Lower Thames Crossing TR010032

Post-events (w/c 4 and 11 September) submission

Thames Crossing Action Group

DEADLINE 4 (19th September 2023) / Submitted 19th September

A2/M2/LTC Intersection

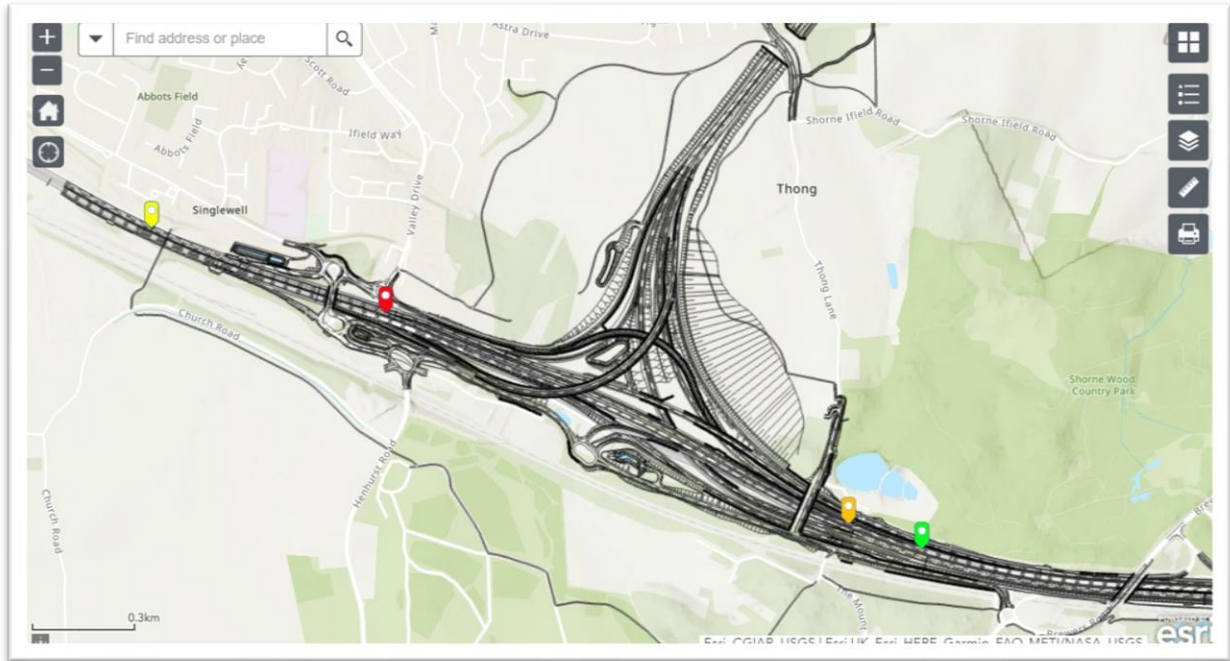
39. We are concerned that the A2 would drop from 4 lanes to 2 for a section in each direction, if the LTC goes ahead.

40. If the LTC goes ahead then the A2 coastbound would drop to just 2 lanes for a section coastbound near Nells Cafe.
